# 1992 - 1993 Corvette: Recall: Power Steering Gear Inlet Hose

**Subject:** PRODUCT SAFETY CAMPAIGN 93CO2 - POWER STEERING GEAR INLET HOSE

**Model and Year:** 1992-93 CHEVROLET LT1 CORVETTE

**Bulletin Number:** 93C02

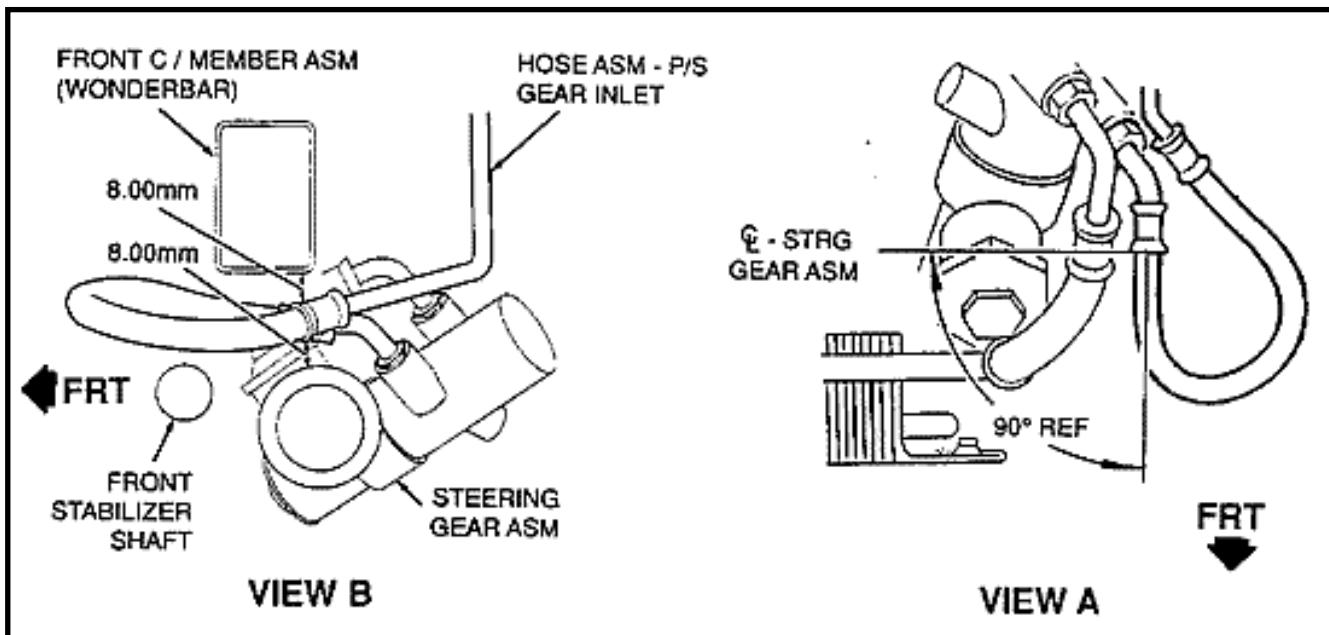
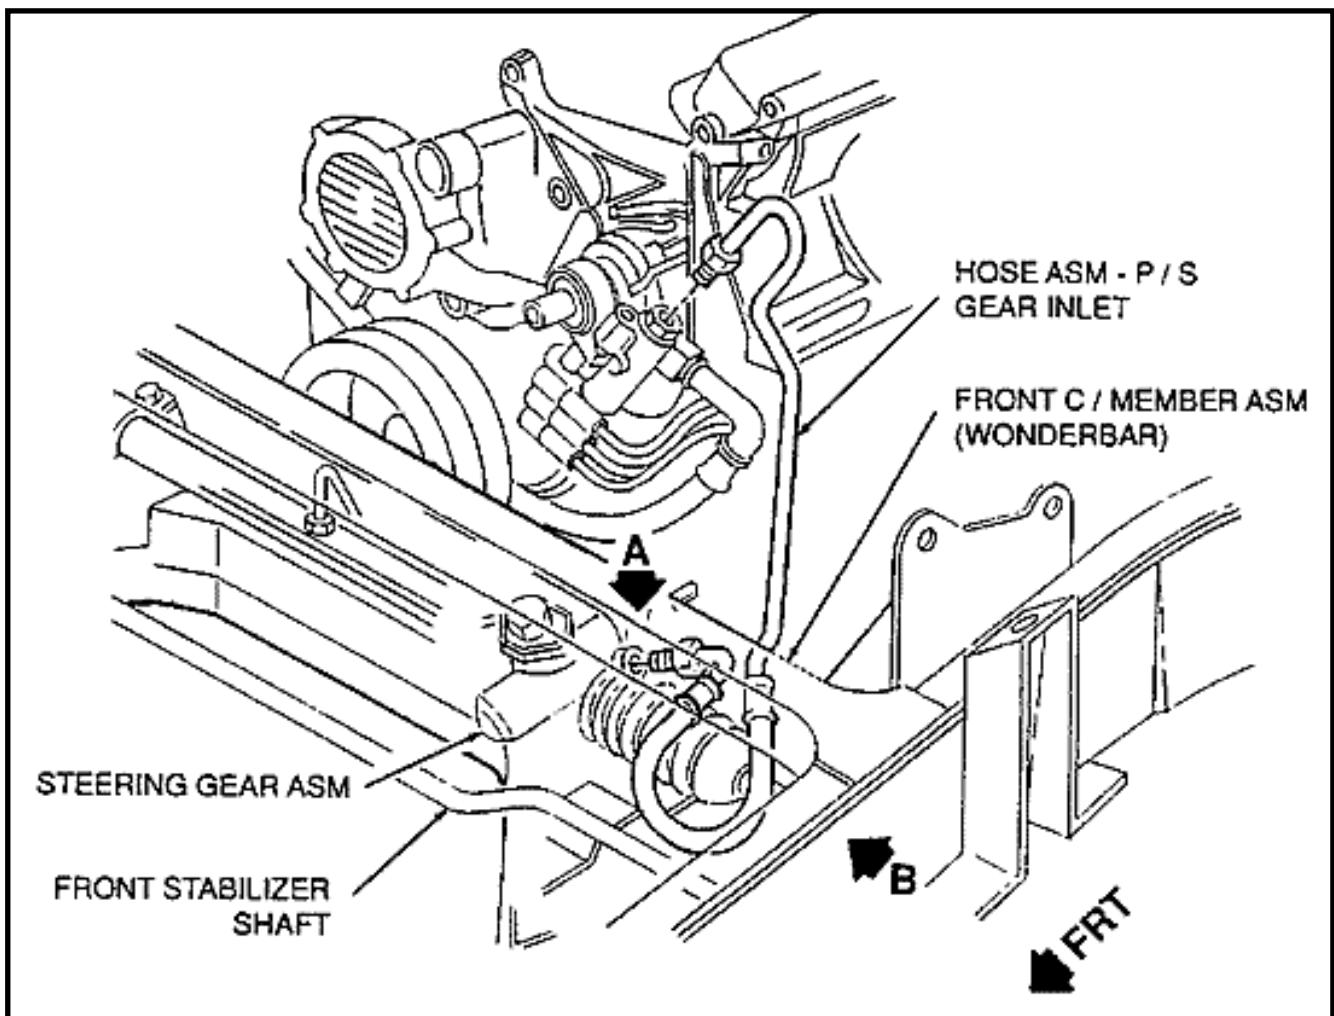
**Notice: Be certain to leave adequate clearance between front cross-member and hose/pipe assembly. View B on page 4 illustrates proper clearance.**

1. Install new power steering gear inlet hose following procedures on page 3B-6 of either

the 1992 Corvette Service Manual (ST-364-92-1) or the 1993 Corvette Service Manual (ST-364-93PSID).
